**ADDENDUM
NO. 4**

October 18, 2024

**Whiteland High School Ph 2: Café Kitchen Band Choir Auditorium
300 E. Main Street
Whiteland, IN 46184**

ARCHITECTURAL LIGHTING - SCHEDULES

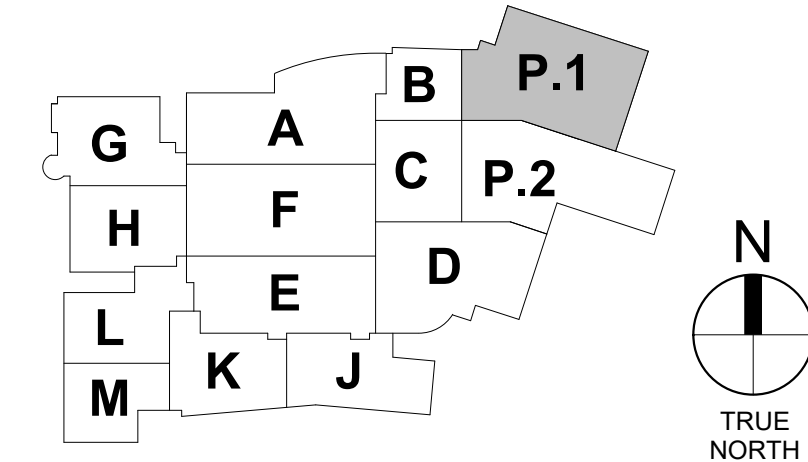
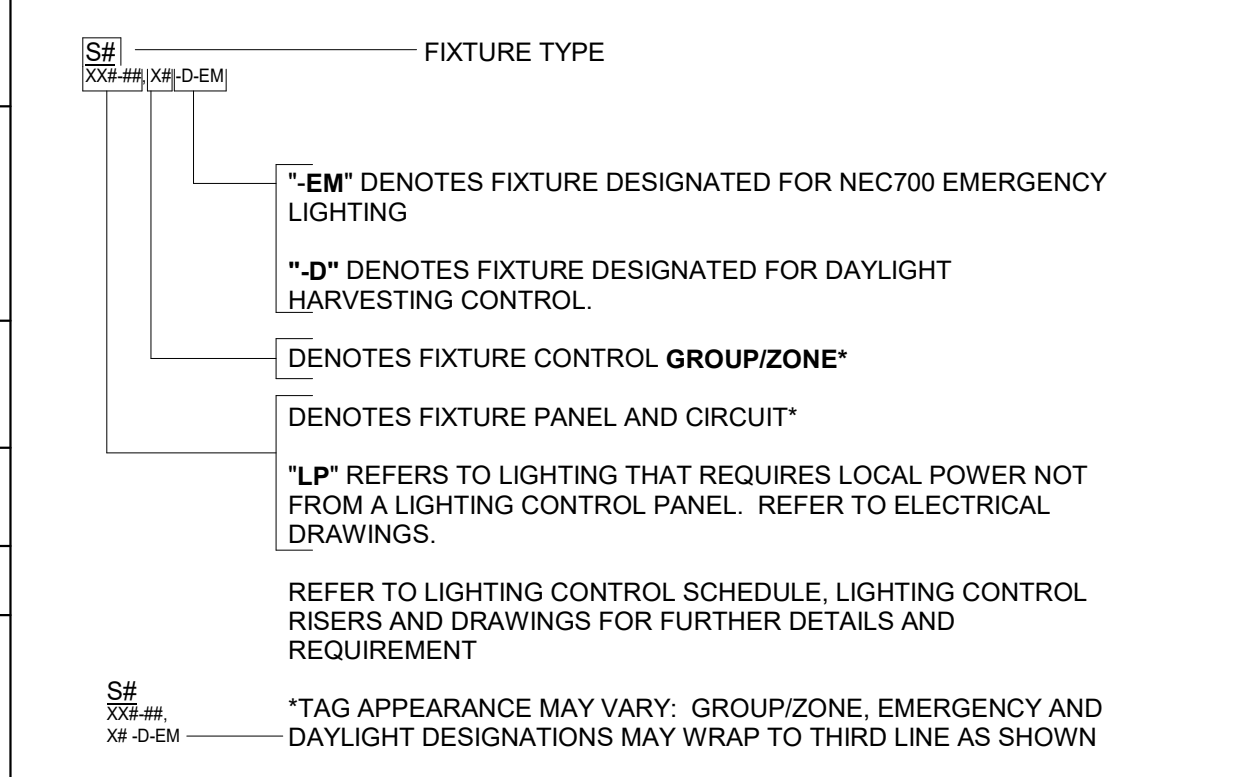
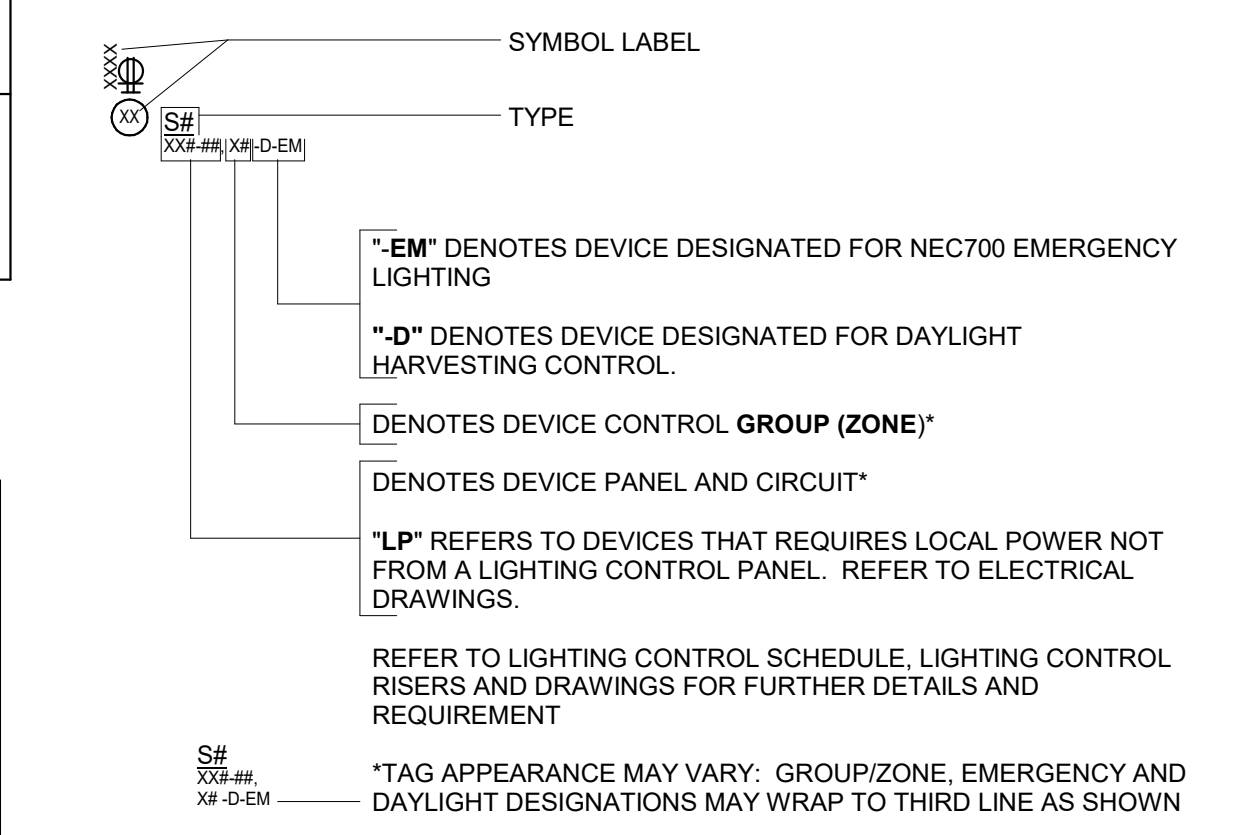
13. Sheet AL500 - ARCHITECTURAL LIGHTING - SCHEDULES: Refer to clouded area of revised sheet for changes:

- c. Added allowable equal manufacturers to several fixtures.

- i. Note that only a cursory review of equals was performed. Every detail was not reviewed.

ROOF DETAILS

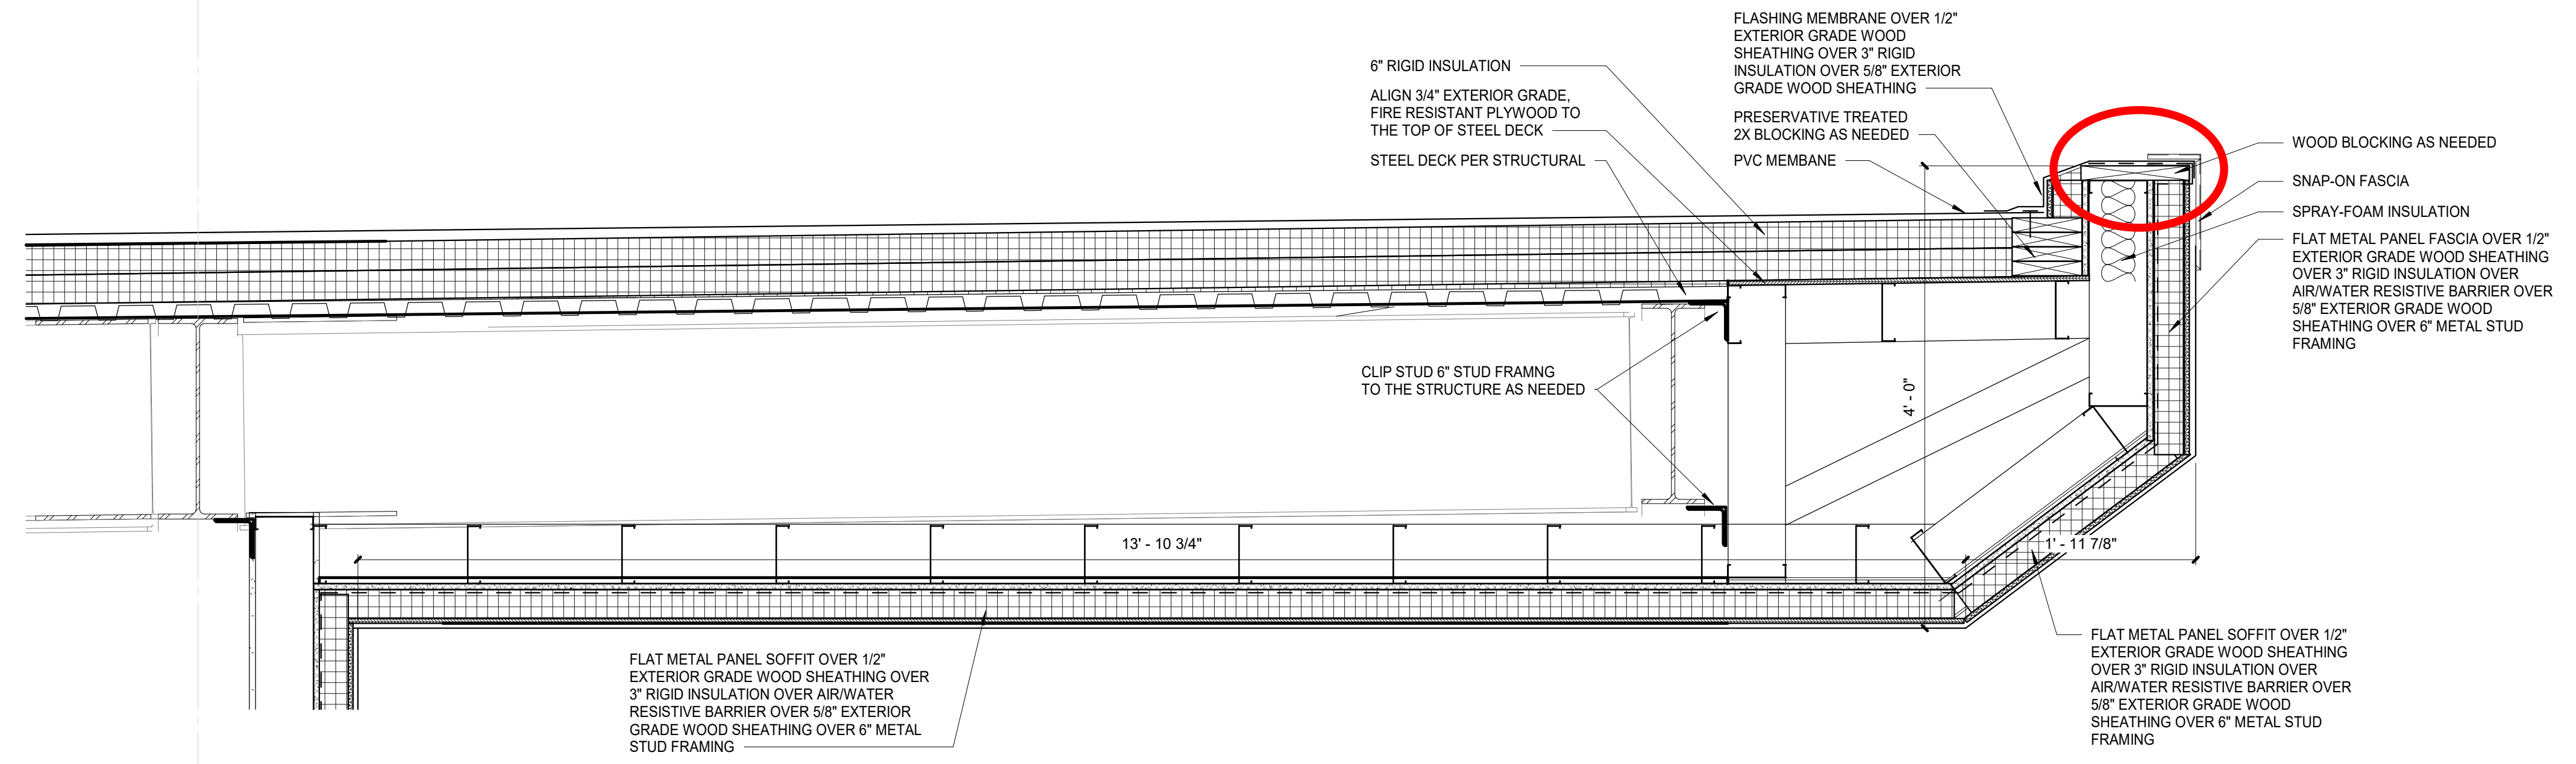
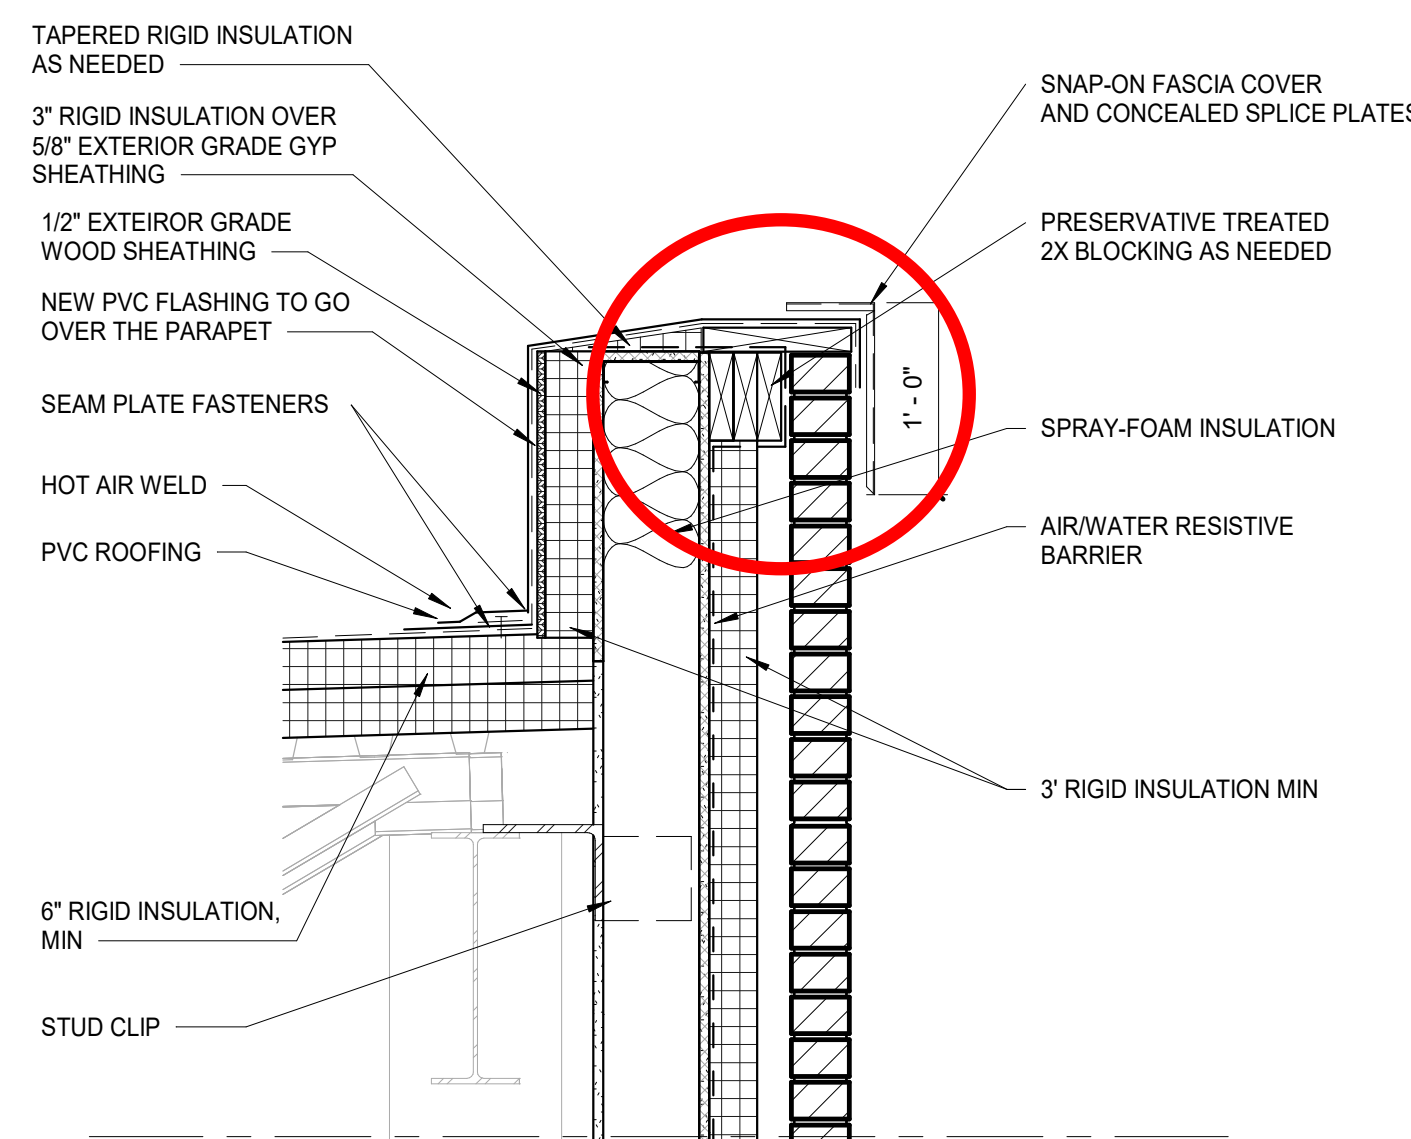
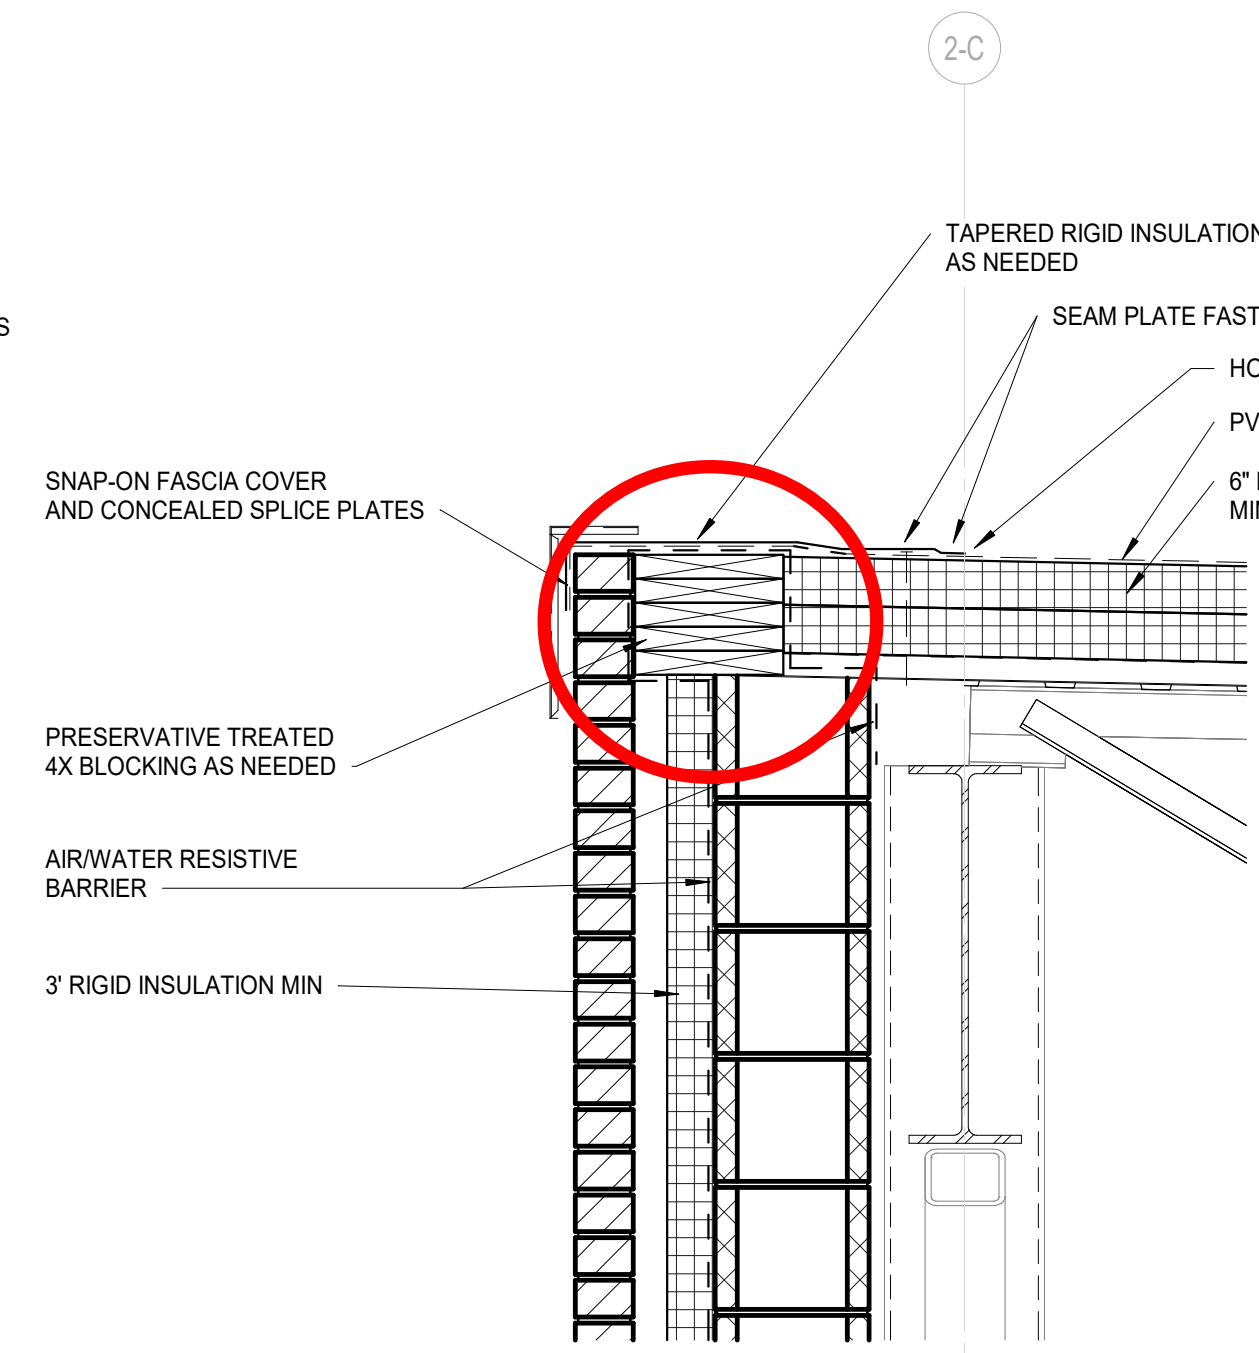
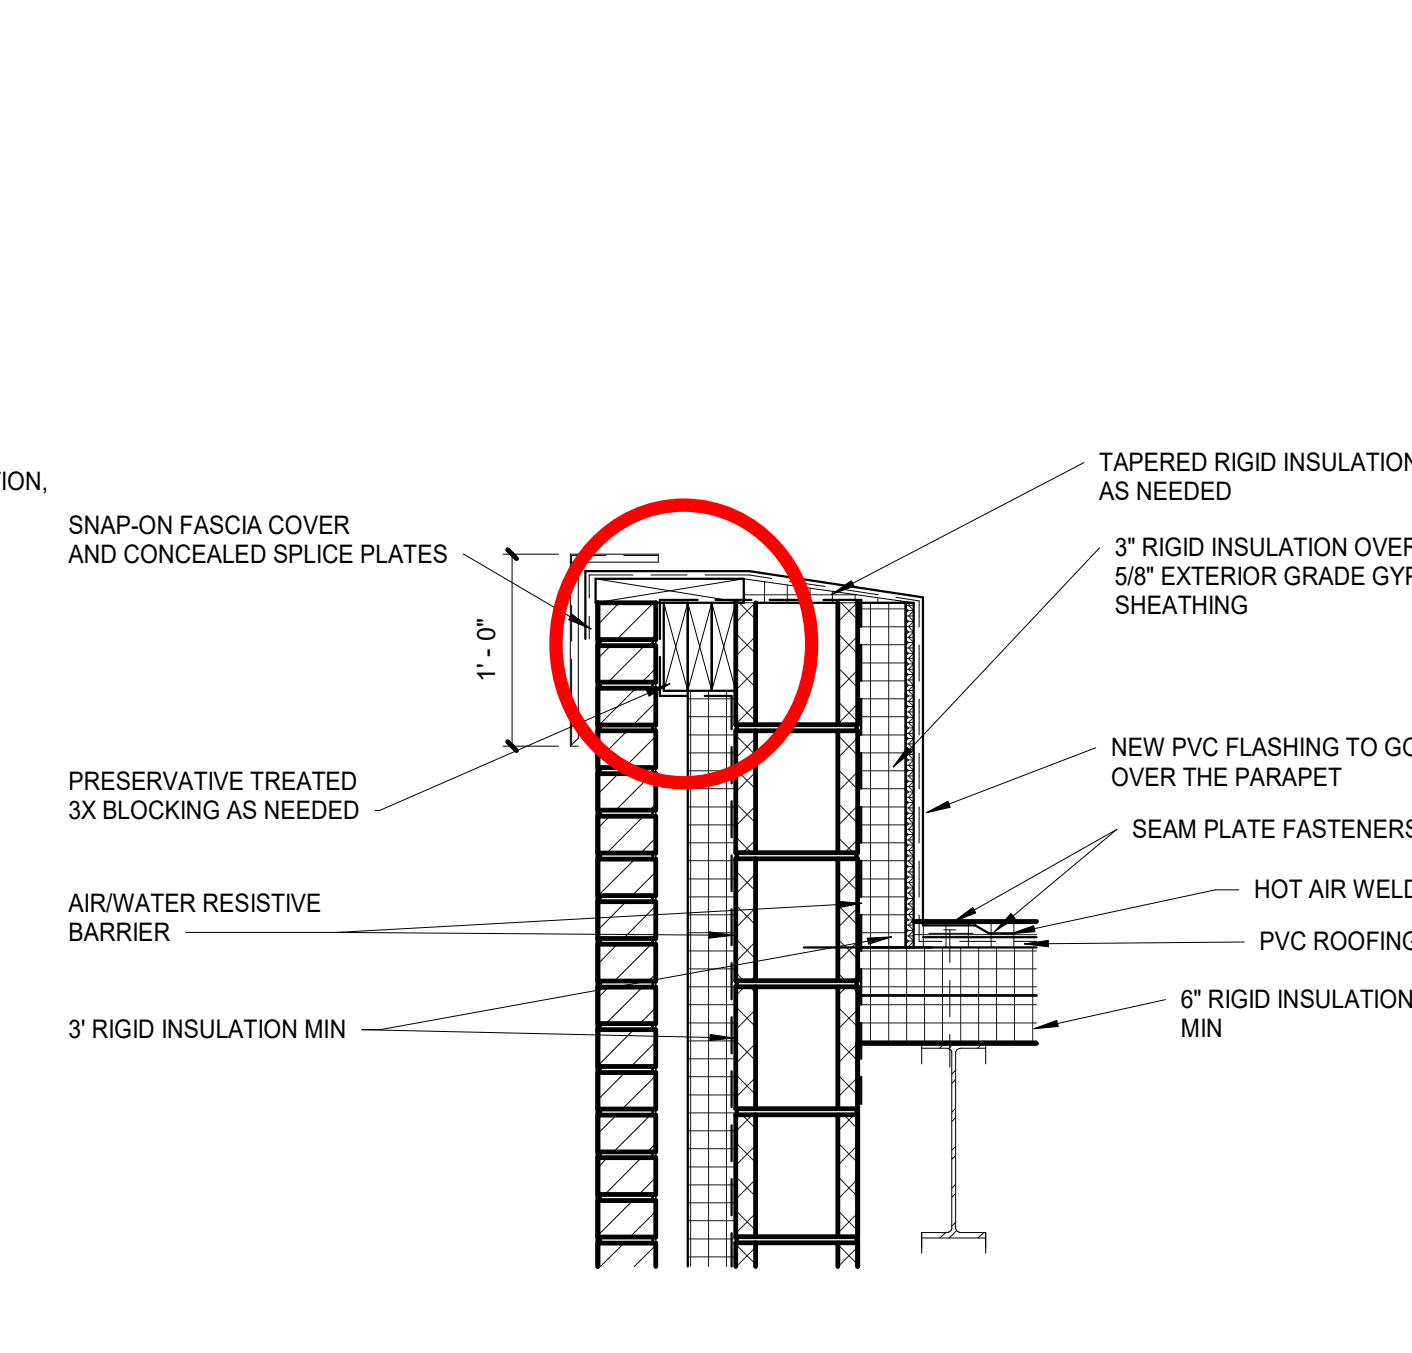
7. Bid Category No. 5 – Metal Studs, Drywall, and Acoustical Contractor is responsible for any board insulation behind metal panels that include Z-Girt installation.
8. Bid Category No. 5 – Metal Studs, Drywall, and Acoustical Contractor is responsible to provide and install all required wood blocking circled in red in the attached

all blocking in question and circled in red will be the responsibility of Bid Category No. 5 Contractor
